# ADDENDUM

Project: Scott Hudgens Park Restroom & Concession Bldg

Addendum No.: One

Date: February 16, 2010

**1 FLOOR PLAN**

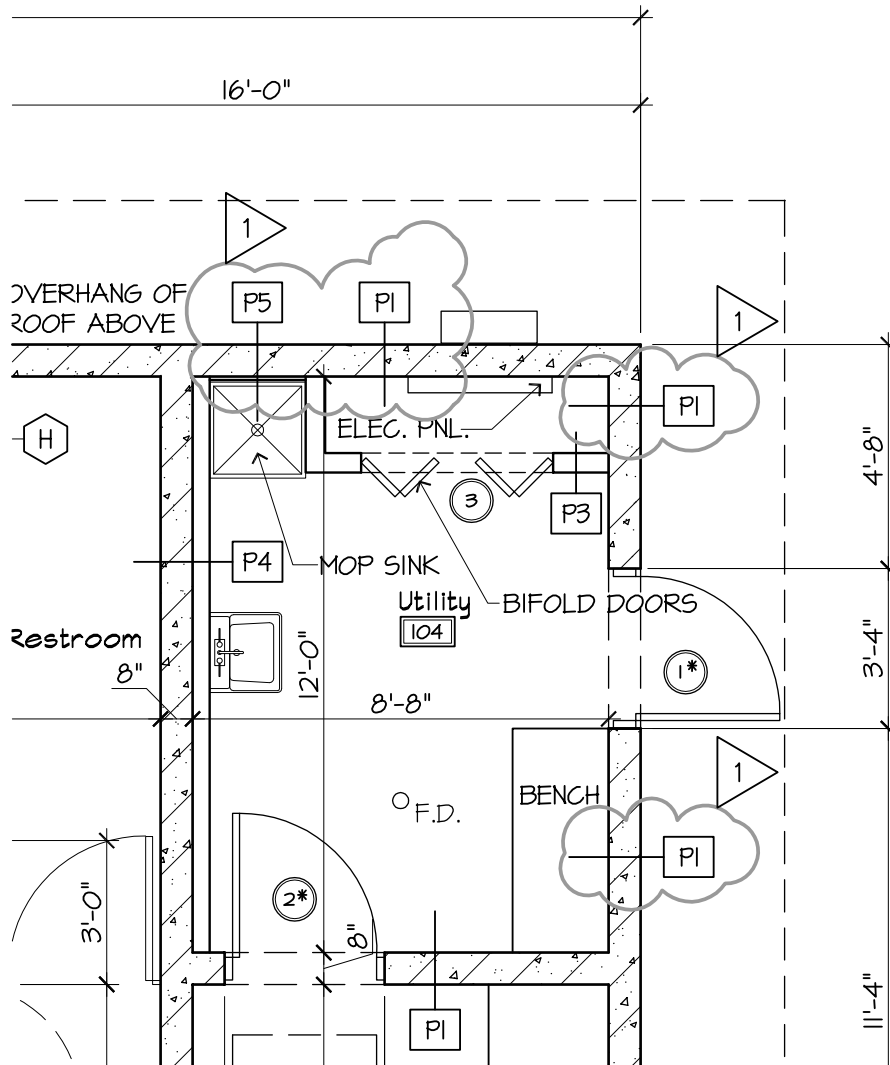
1. Partition types and locations for FRP have been clarified in attached sketch 1 of 5 on sheet A.1.
2. Door hardware has been revised to clarify electronic locking requirements. See attached Door Hardware Specification and sketch 2 of 5 on sheet A.1.

MARKER:	NOTED	DESCRIPTION:
		1/2" CEMENT BACKER BOARD FACED WITH F.R.P ON SINGLE SIDE OVER 7/8" HAT CHANNELS SPACED AT 24" VERTICALLY, 8" (NOMINAL) C.M.U. WALL ASSEMBLY. TRUSS TYPE MASONRY REINFORCEMENT AT 16" ON CENTER VERTICAL.

## HARDWARE SCHEDULE

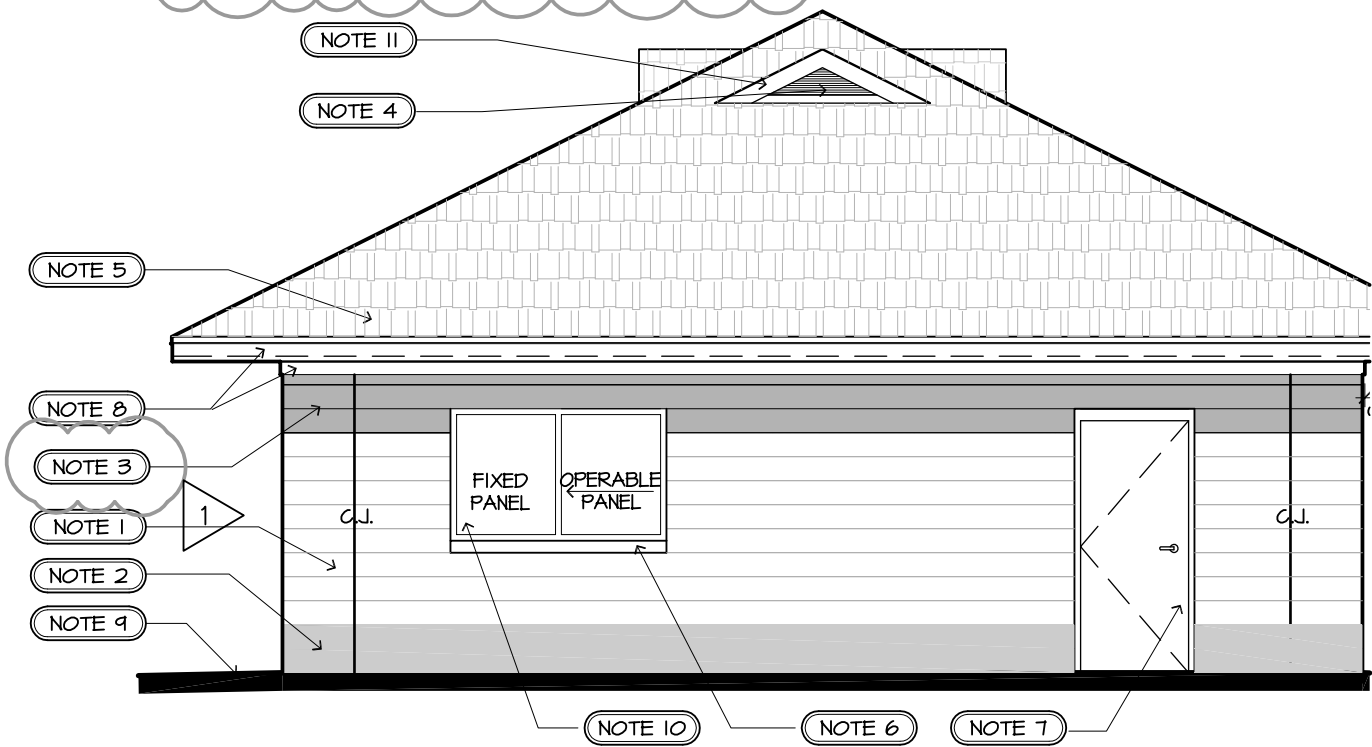
**Hardware Set No. 4** listed on Sheet A-1, shall be deleted and replaced with the following.

**Hardware Set No. 1** listed on Sheet A-1, shall delete the following notes:

3	HINGES	BB1168 4-1/2X4-1/2X32D, NRP	HAGAR
1	STOREROOM LOCK	ND80PD-VANDALGUARDXSPARTAXUS26D	SCHLAGE
1	ELECTRIC STRIKE	6210 24V	VON DUPRIN
1	POWER SUPPLY	LSE 505	SCHLAGE
1	DIGITAL TIMER	LSE 6200	SCHLAGE
1	SET DOOR SEALS	A625A	NGP
1	SILL SWEEP	C627A	NGP
1	THRESHOLD	846N	NGP
1	MEN/WOMEN SIGN

Power supply powers fail secure electric strike. Should power go off, lock remains locked and door is secure; key override to enter restroom. Free egress at all times.

Digital timer in power supply is programmable to provide for unlocking and relocking at specified time. Timer installs inside LSE 505 power box located in electrical panel closet. GC to coordinate programming schedule with Owner and provide training on use and maintenance.

Power supply requires 120VAC power input. Electric strike is powered from the power supply at 24V. See power plan E-1.0.

“PROVIDE SECURITY KEY PAD FOR ACCESS CONTROL COORD. W/ SECURITY AND ELECTRICAL. GC TO COORD. W/ OWNER FOR EXACT RQMTS.”

“PROVIDE ELECTRIC STRIKE BY VON DUPRIN, HEAVY DUTY STAINLESS STEEL W/ ADJUSTABLE STRIKE BOX, TWO PIECE PLUG CONNECTORS. COORD. W/ SECURITY AND ELECTRICAL.”

Additionally, the back box and ¾” conduit called for on the E1.0 Power Plan shall be deleted to doors No. 1. (Two locations).

1 WALL SECTION  
A.4

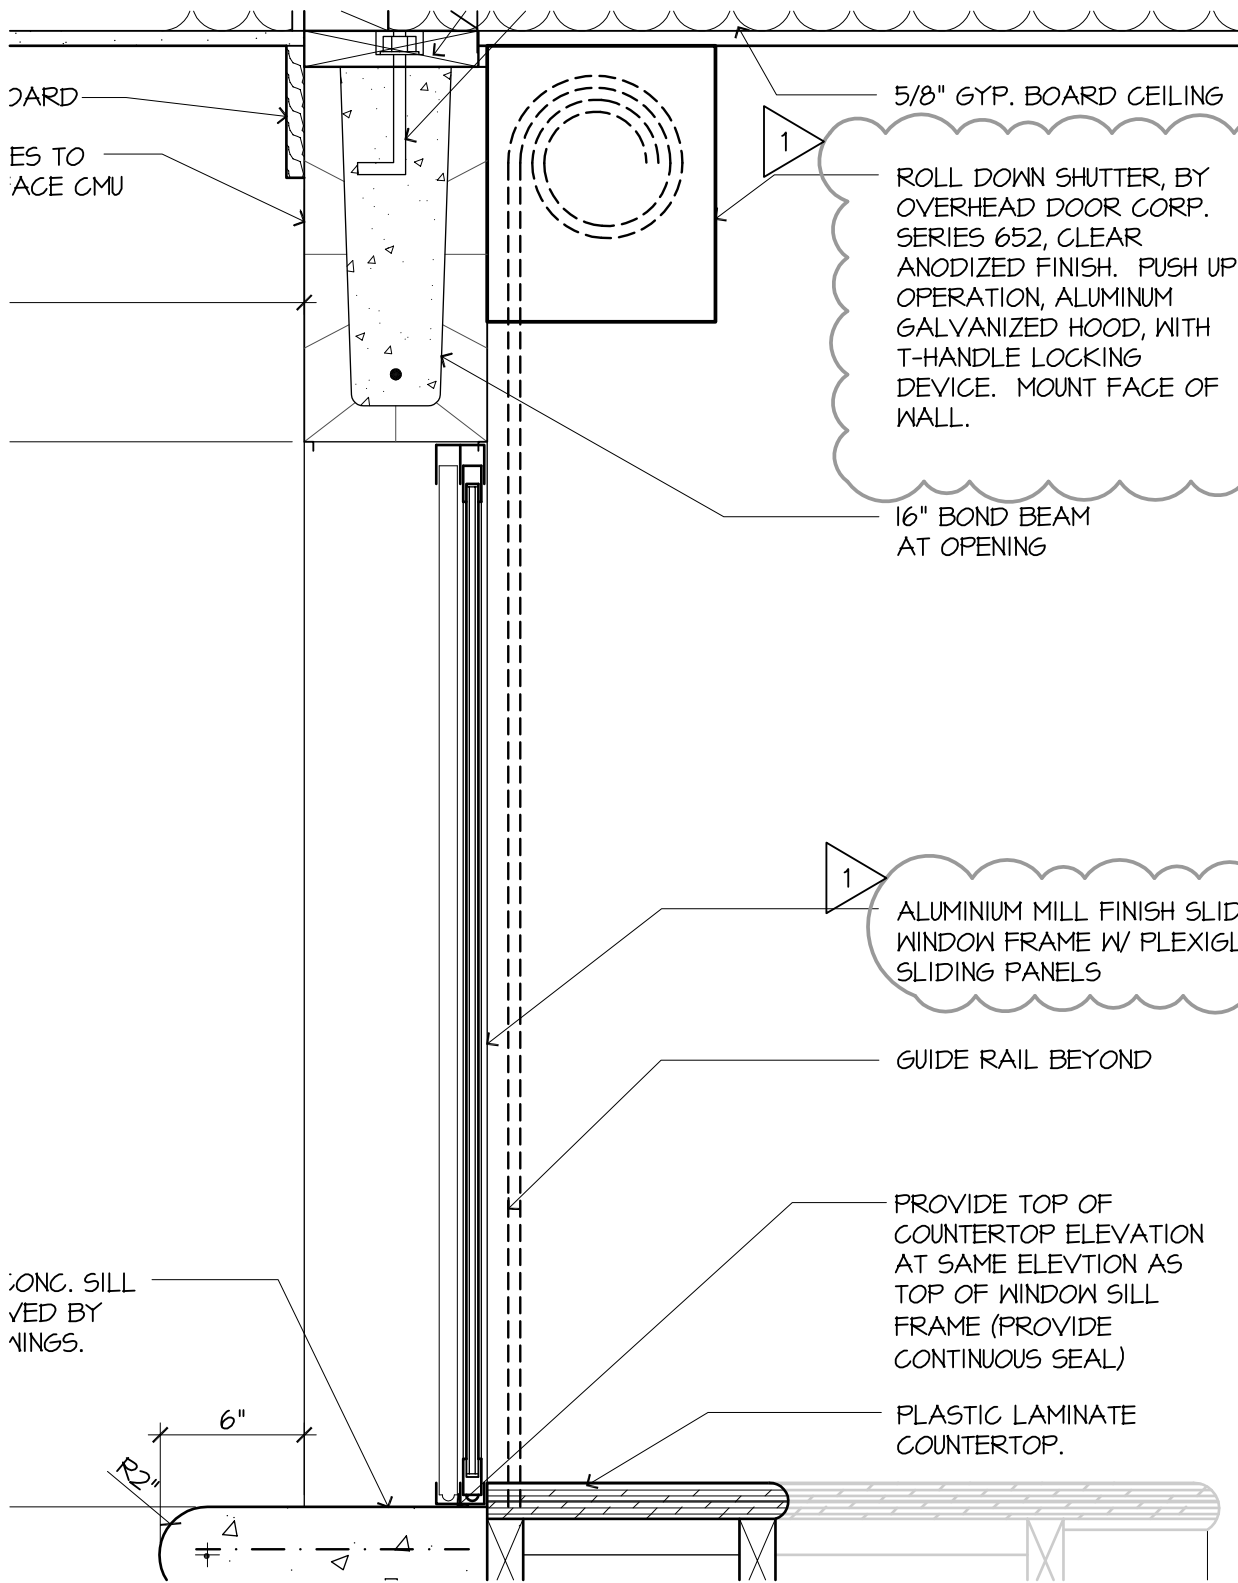
4. Roll up counter door specifications have been added to detail on A.4, see sketch 4 of 5.
5. Sliding window to be Aluminum mill finish, see attached detail A.4, see sketch 4 of 5.

**EXTERIOR SLAB TURNDOWN**

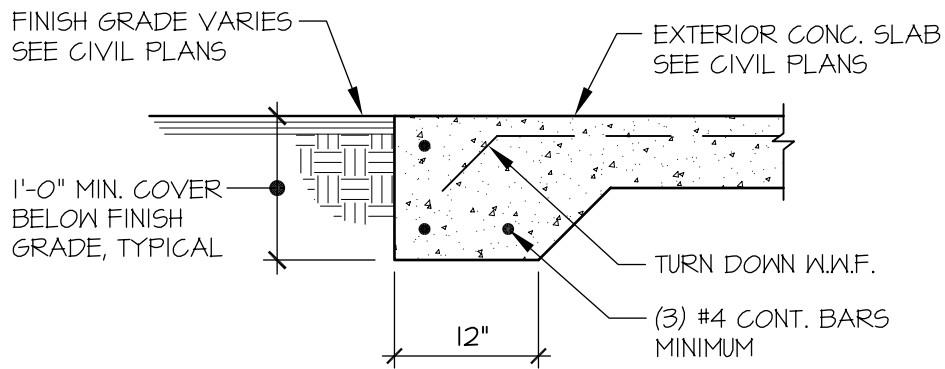
6. Clarification is provided for the concrete paving parking area. Refer to detail 105 added to sheet S2.1 for the perimeter parking detail and slab construction. See sketch 5 of 5.
